**Re: Lot 6 Block 4 Unit 18 Volcano Cliffs, S.A.D. 228
6600 Papagayo NW
Request Permanent C.O. – Accepted
Engineer's Stamp dated: 1-2-18 (D10D003J6)
Certification dated: 2/11/19**

CITY OF ALBUQUERQUE, BERNALILLO COUNTY				NEW MEXICO	
LOT 6, BLOCK 4, UNIT 18 VOLCANO CLIFFS SUBDIVISION					
PECK (BUILDER: MICHAEL SANCHEZ) – GRADING & DRAINAGE PLAN					
McDowell Engineering, Inc.					
7820 BEVERLY HILLS AVE. NE • ALBUQUERQUE, NM 87122					
TELE: 505-828-2430 • FAX: 505-821-4857					
Designed	JSM	Drawn	STAFF	Checked	JSM
					Sheet of
File	PEC0117L		Date	DECEMBER, 2017	
				1	1

**Re: Lot 6 Block 4 Unit 18 Volcano Cliffs, S.A.D. 228
6600 Papagayo NW
Request for Permanent C.O. – Not Accepted
Engineer's Stamp dated: 1-2-18 (D10D003J6)
Certification dated: 1/23/19**

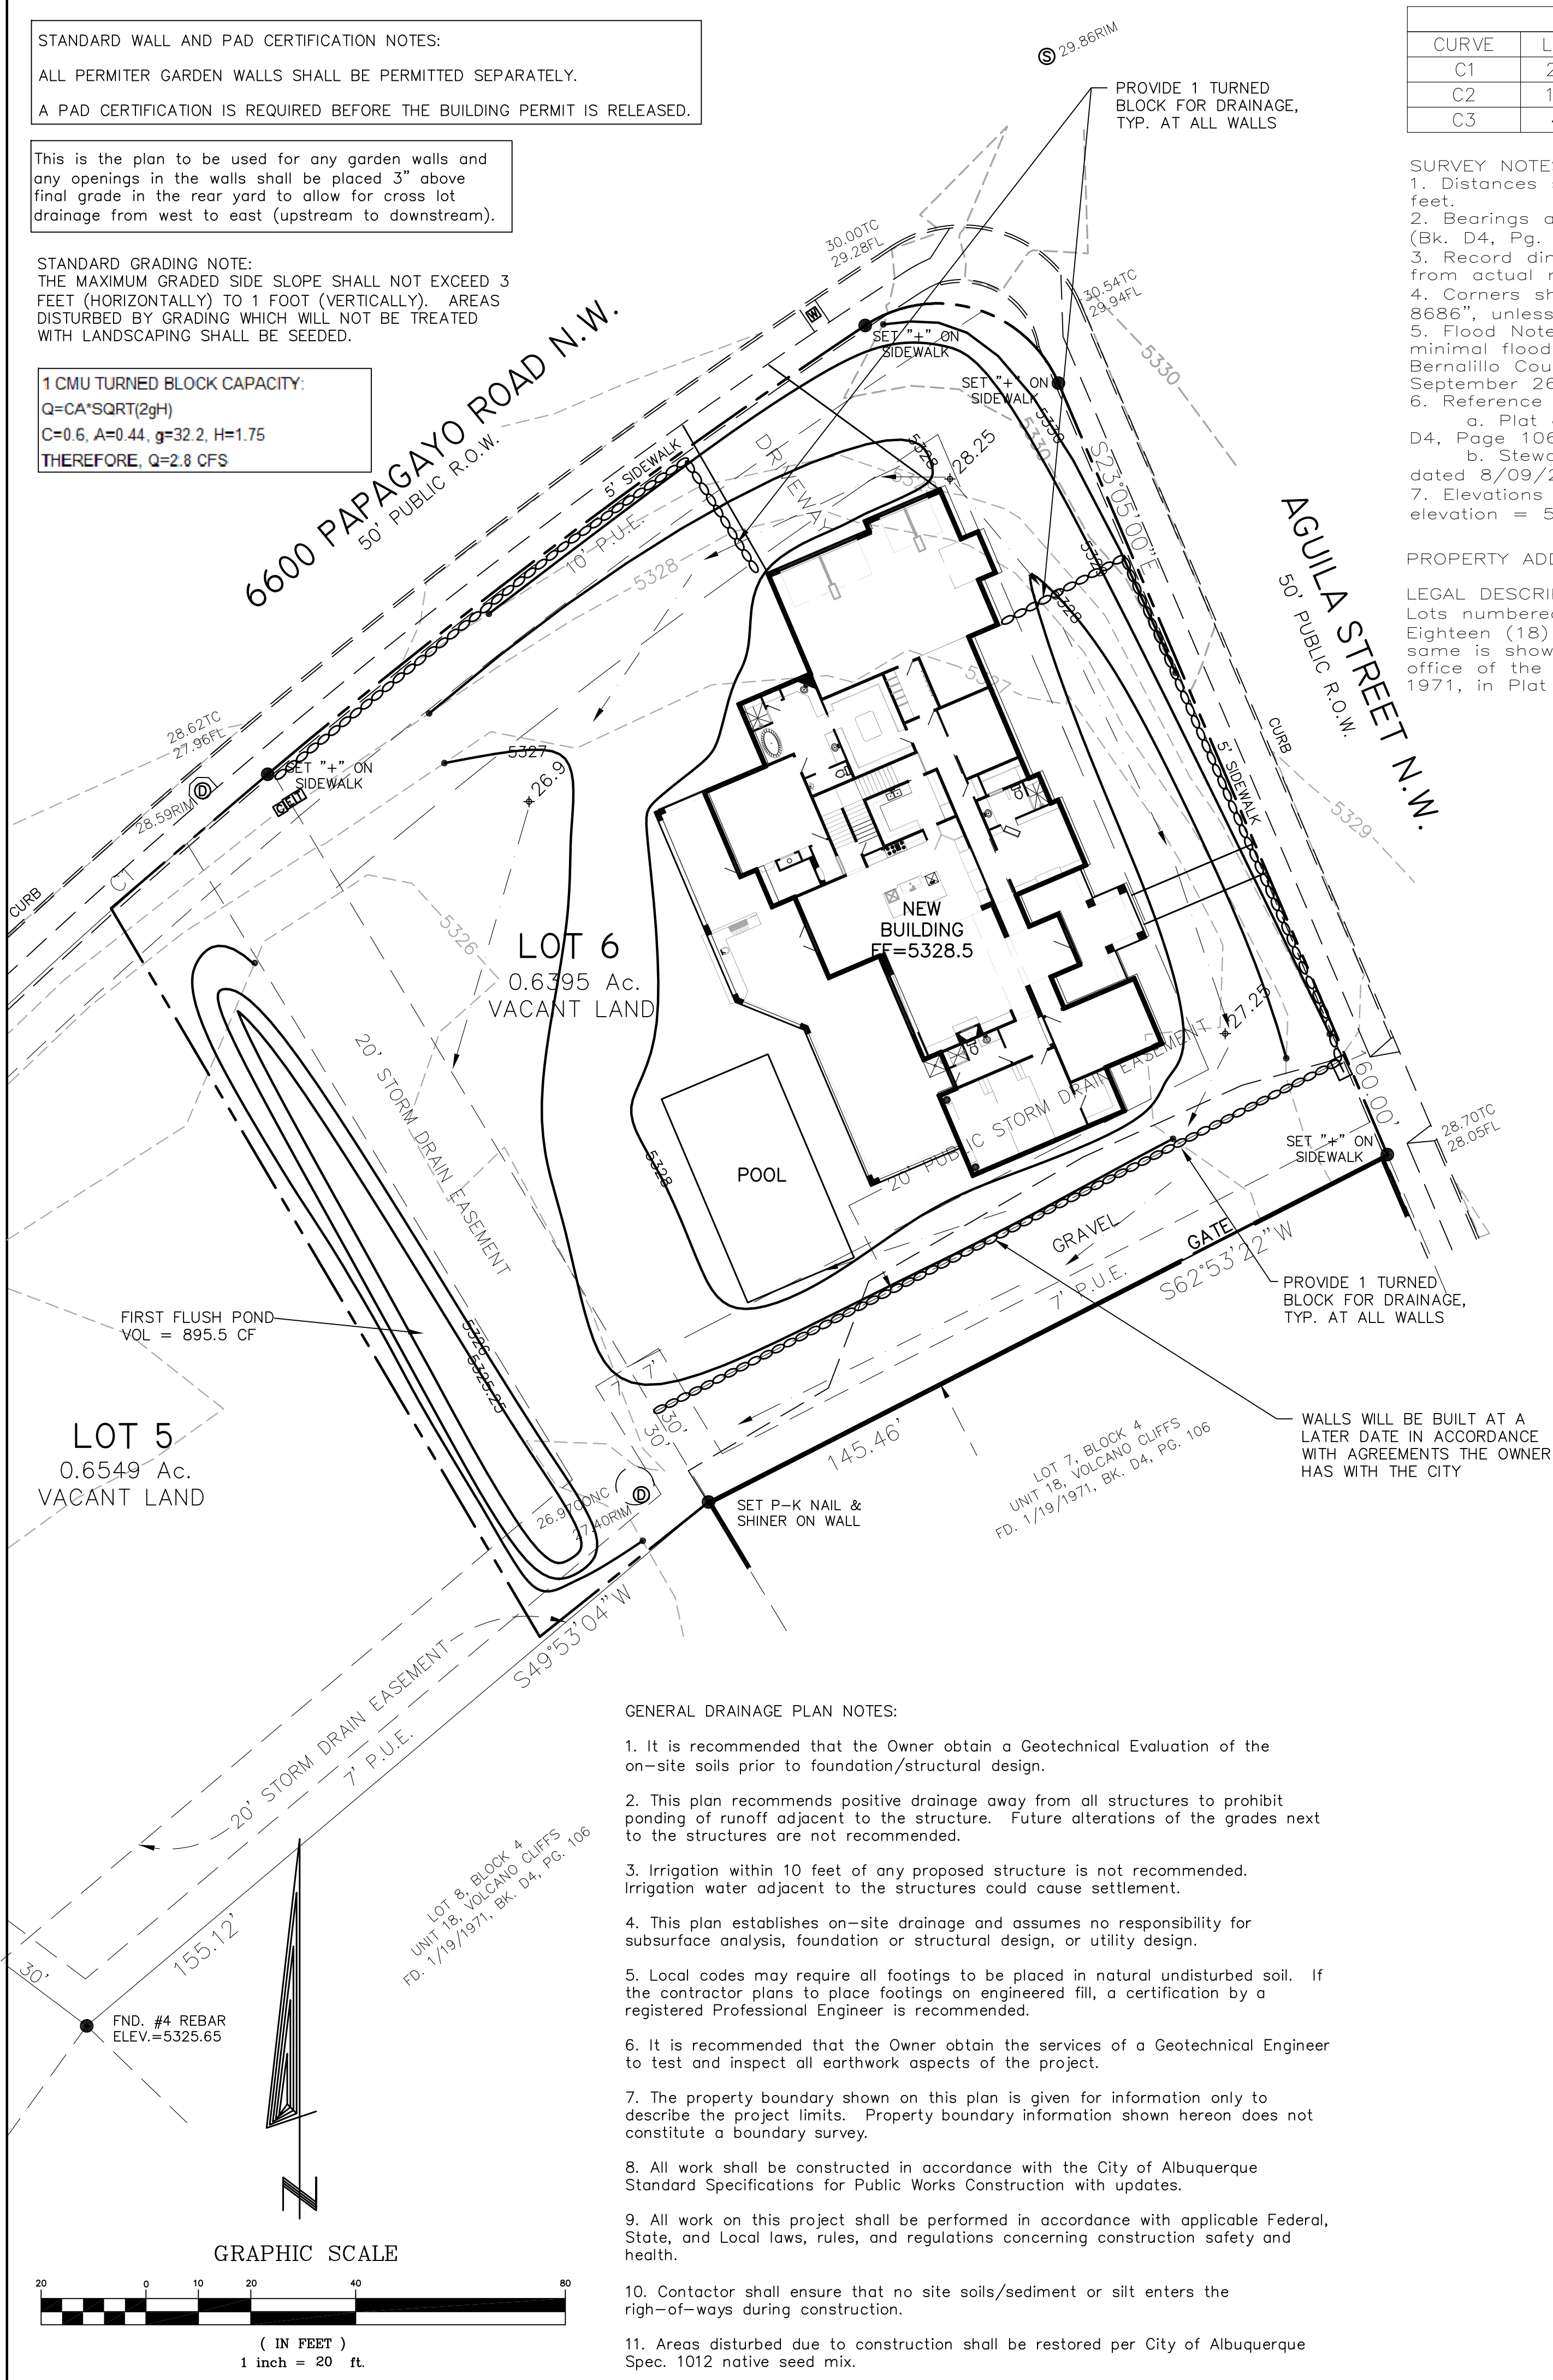
- Provide the new plat for this address, it appears that the lot line was moved. **attached**
- Provide the location of the 20' SD easement, one of the hatched lines are missing. **updated**
- Provide the new calculations including the pool area. Treatment D should have increase along with the ponding area. **updated, even though pools typically store water, updated to treat as Treatment D, per your direction.**

ZONE 1 UPDATED CALCS FOR UPDATED PROPERTY AND POOL
